UNITED STATES PATENT AND TRADEMARK OFFICE

APPLICATION NO.	FILING DATE	FIRST NAMED INVENTOR	ATTORNEY DOCKET NO.	CONFIRMATION NO.
10/718,593	11/24/2003	Helmut Schwarz	P24519	1224
7055	7590	07/05/2005	EXAMINER	
GREENBLUM & BERNSTEIN, P.L.C.			MITCHELL, KATHERINE W	
1950 ROLAND CLARKE PLACE			ART UNIT	
RESTON, VA 20191			PAPER NUMBER	
			3677

Office Action Summary

DETAILED ACTION

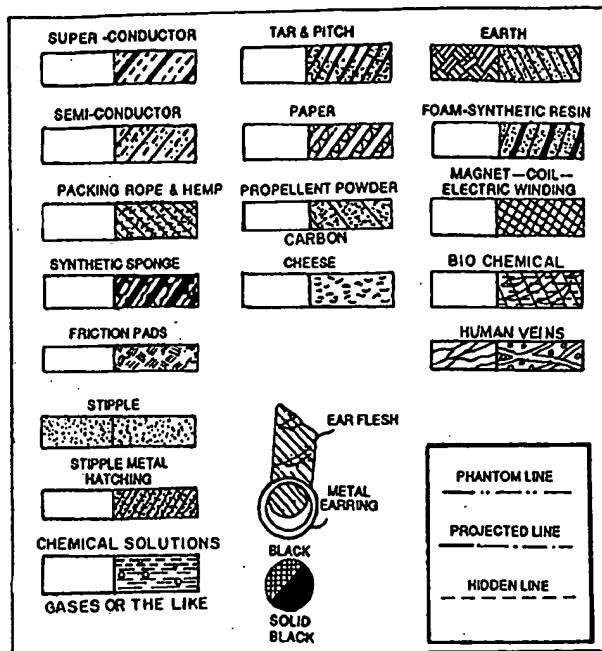
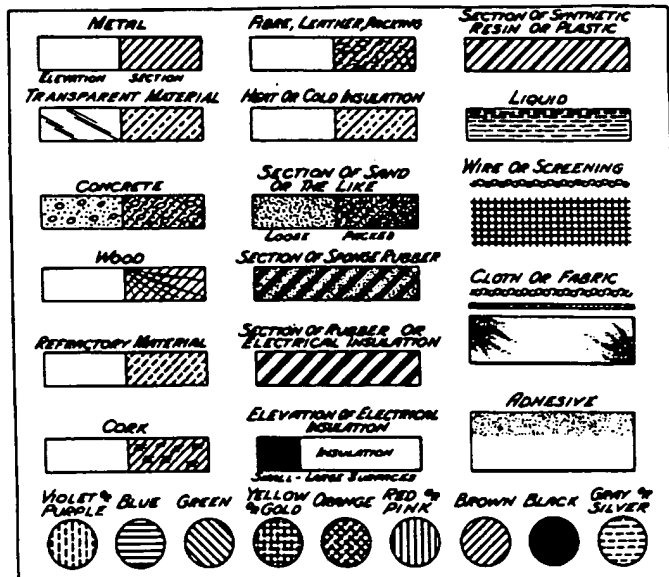
2. The drawings are objected to because the hatching in Figs 1 and 3 is improper.

Corrected drawing sheets in compliance with 37 CFR 1.121(d) are required in reply to the Office action to avoid abandonment of the application. Any amended replacement drawing sheet should include all of the figures appearing on the immediate prior version of the sheet, even if only one figure is being amended. The figure or figure number of an
